Montana Market

City Plan Commission — July 2, 2026 **REVISED**

CASE NUMBER/TYPE:	SUSU26-00036 – Major Combination
CASE MANAGER:	Blanca Perez, (915) 212-1561, PerezBM@elpasotexas.gov
PROPERTY OWNER:	River Oaks Properties, LTD
REPRESENTATIVE:	SLI Engineering, Inc.
LOCATION:	North of Montana Ave. and West of Airway Blvd. (District 3)
PROPERTY AREA:	11.60 acres
VESTED RIGHTS STATUS:	Not Vested
PARK FEES:	\$11,600.00
EXCEPTIONS/MODIFICATIONS:	Yes, see following section
ZONING DISTRICT(S):	C-2/sp (Commercial/special permit) and C-4/sp (Commercial/special permit)
RELATED APPLICATIONS:	PZR26-00011 – 6375 Montana

SIOUX STREET "B - B"

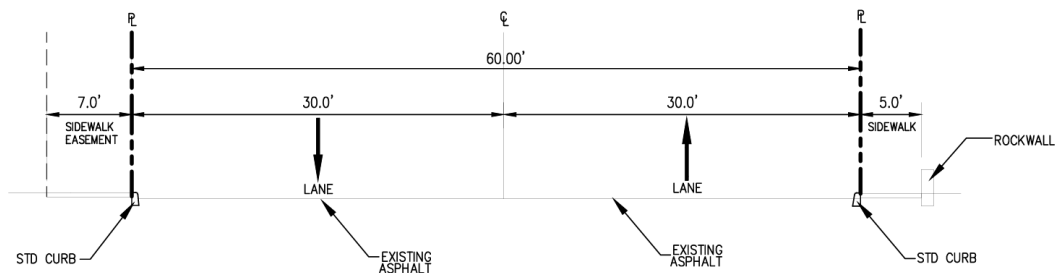
Waiver request for Sioux Street:

- To waive the dedication of five and a half feet (5.5') of additional right-of-way along Sioux Street.

REQUIRED CROSS-SECTION FOR SIOUX STREET:

Collector - Drivable Suburban (R.O.W: 71 Feet)						
	Typical Lanes/Widths	Medians/Access	On-Street Parking	Streetscape Elements	El Paso Bike Plan Bike Facilities	Min. Sidewalk Width
G-7 Industrial	2-4 lanes, depending on traffic volumes. 10-11 foot lane widths may be used	Medians or TWLTL	Allowed	Sidewalks critical to preserve; other streetscape is a lesser priority	Bike Lanes or Sidepaths	5 ft

ISHA WAY "A - A"

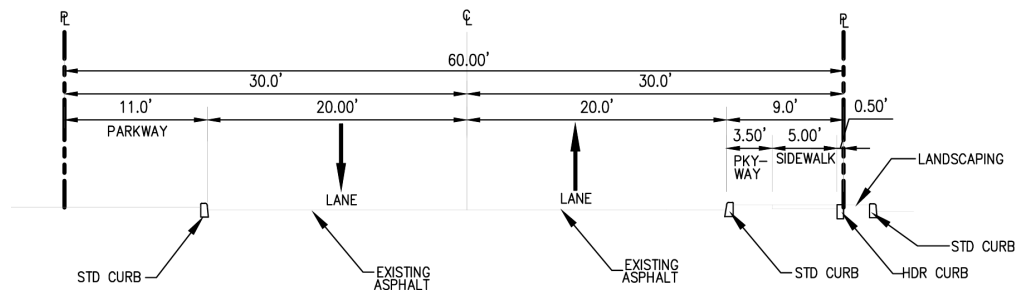
Waiver request for Isha Way:

- To waive the construction of one and a half (1.5') of planter strip along Isha Way.

REQUIRED CROSS-SECTION FOR ISHA WAY:

Local-Drivable Suburban (R.O.W: 60 Feet)						
	Typical Lanes/Widths	Medians/Access	On-Street Parking	Streetscape Elements	El Paso Bike Plan Bike Facilities	Min. Sidewalk Width
G-7 Industrial	2 lanes. May use lane widths of up to 14 ft	Not Applicable	Allowed	Planter strip, which may be substituted with hardscape materials for special treatments such as bus stops	Bike Lanes or Bicycle Boulevard	5 ft

Figure B: Developed properties within a quarter mile of proposed subdivision

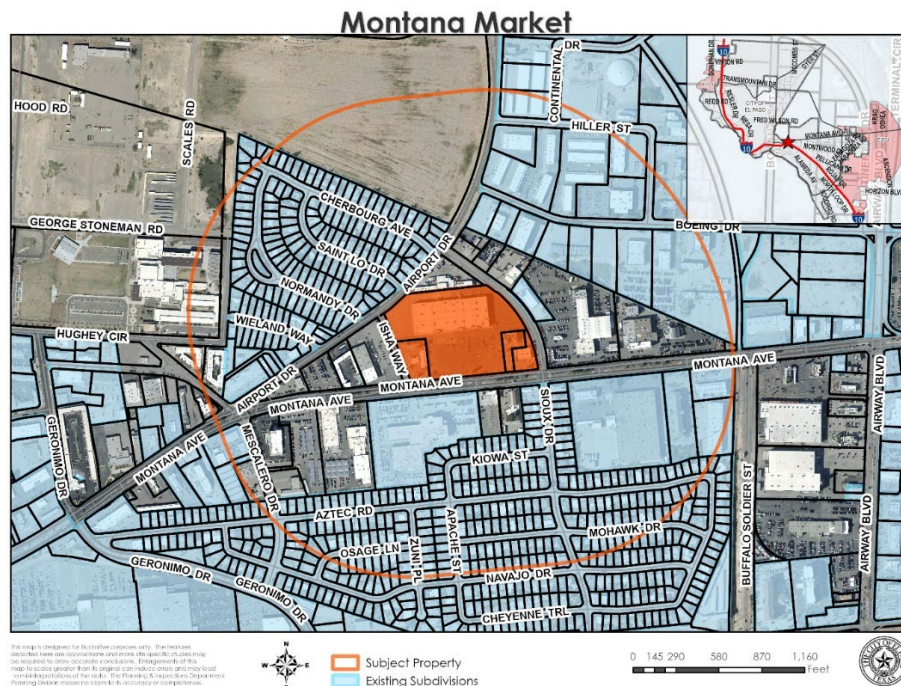
a: Fifty per cent of the lots within a quarter mile of the proposed development have already been developed and the existing street improvements are in character with the neighborhood.

PRELIMINARY PLAT

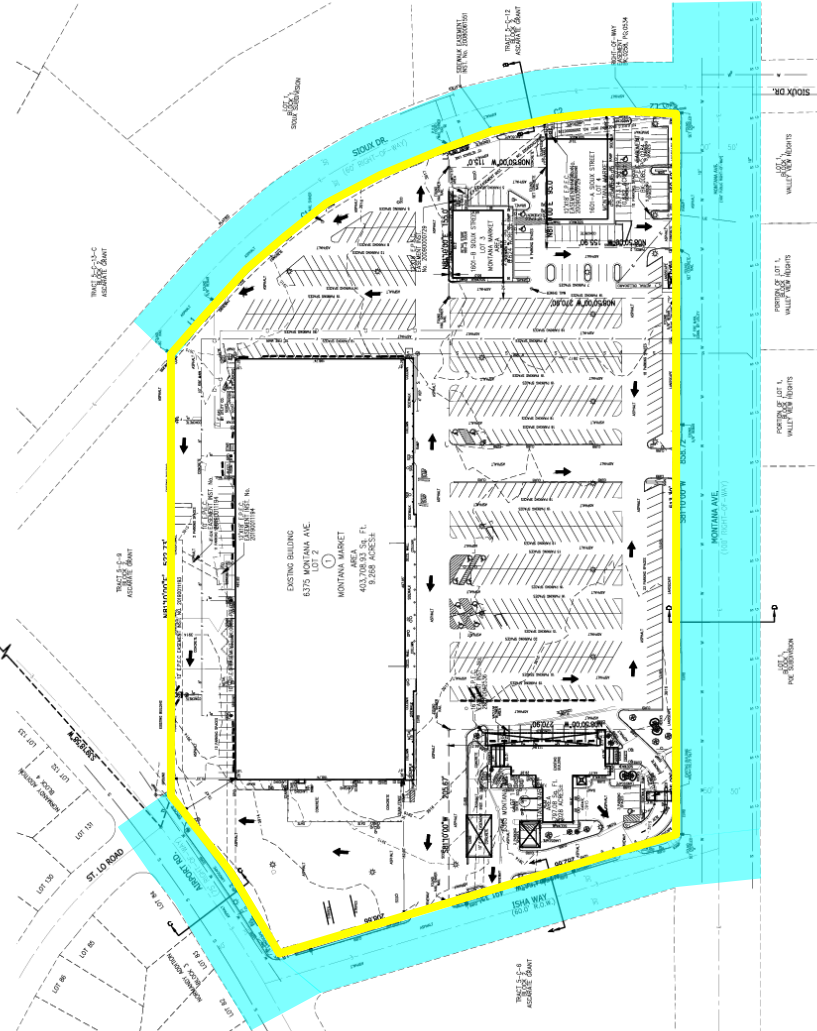
1. Submit to the Planning & Inspections Department – Planning Division the following prior to recording of the subdivision:
 - a. Current original tax certificates with zero balance.
 - b. Original copies of the Restrictive covenants.
2. Update plat note number 4, as instrument number belongs to another subdivision.
3. Remove plat note number 10.
4. Update addresses for Lot 3 and Lot 4.

1. The code encourages the use of nonstructural storm water management such as the preservation of greenspace, rainwater harvesting within landscape areas to the maximum extent practicable, per Chapter 19.19, Section 19.19.010, and Subparagraph A-2 & A-5.
2. Secure drainage easement agreements between lots.
3. Boundary closure report is ok.
